SERVICE BULLETIN

Service Bulletin No.: DA20-72-02 Rev 0

Title: DA20-A1 – Evans NPG+ Coolant

CHANGE OF COOLANT SPECIFICATION ON ROTAX® ENGINE TYPE 912 AND 914 (SERIES)

- 1 Expansion tank
- 2 Warning sticker
- 3 Radiator cap
- 4 Excess-pressure information

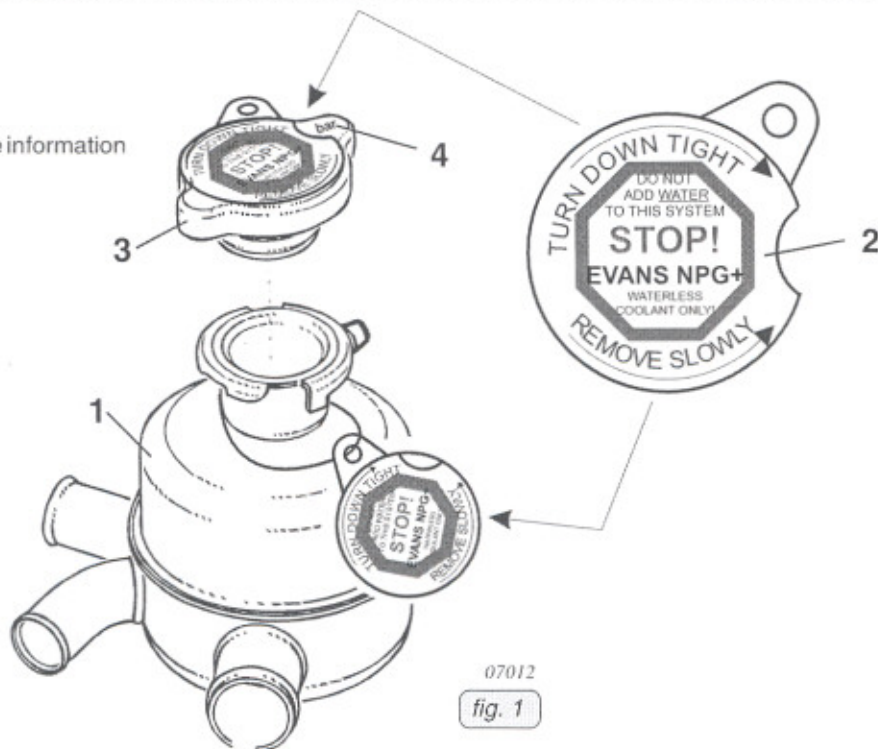
◆ **NOTE:** On the radiator cap (3), to identify the new coolant, the warning label (2) is to be affixed so that the opening pressure data (4) is visible.

- For new engine deliveries the sticker will be temporarily attached to the expansion tank.
- The sticker has to be affixed to the radiator cap in accordance to the aircraft manufacturer's instruction.
